Darnestown at Travilah, Site Plan Amendment 82010007A

Completed: 3/8/12

Description

Previously Approved Façade Illustration

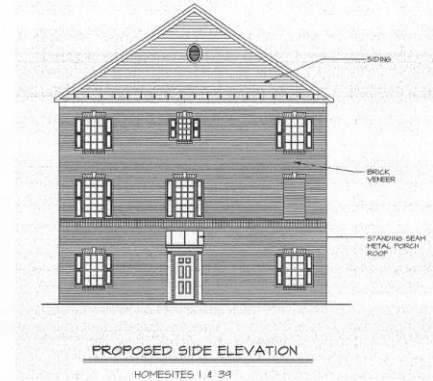
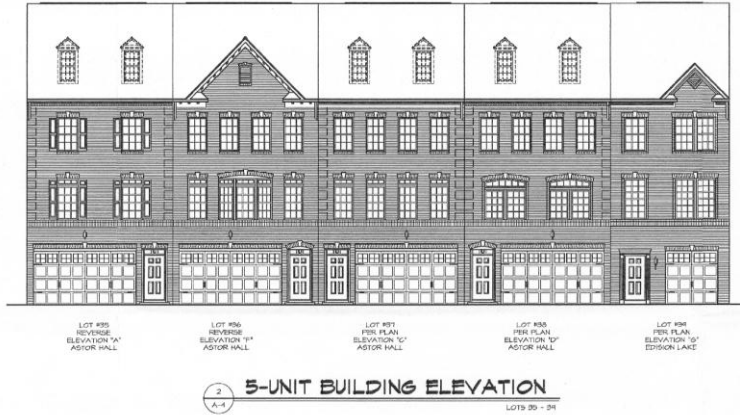
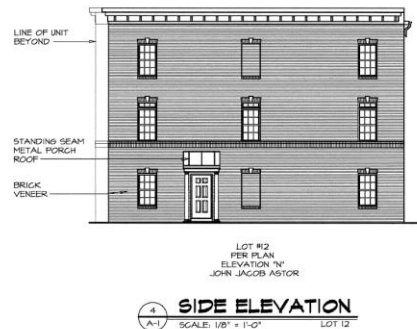
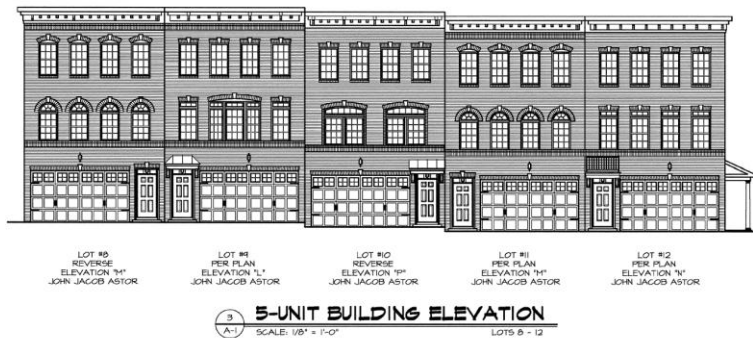
1. Change from a peaked roof to a flat roof; and
2. Minor modifications of door and window placement and façade design.

The proposed modifications to the site plan do not alter the overall design character of the development in relation to the original approval and the site remains compatible with existing and proposed development adjacent to the site. The modifications do not impact the efficiency, adequacy, or safety of the site with respect to vehicular and pedestrian circulation, open space, landscaping, or lighting. The proposed amendment remains in conformance with the original Planning Board findings of approval.

Staff recommends approval of site plan amendment 82010007A.
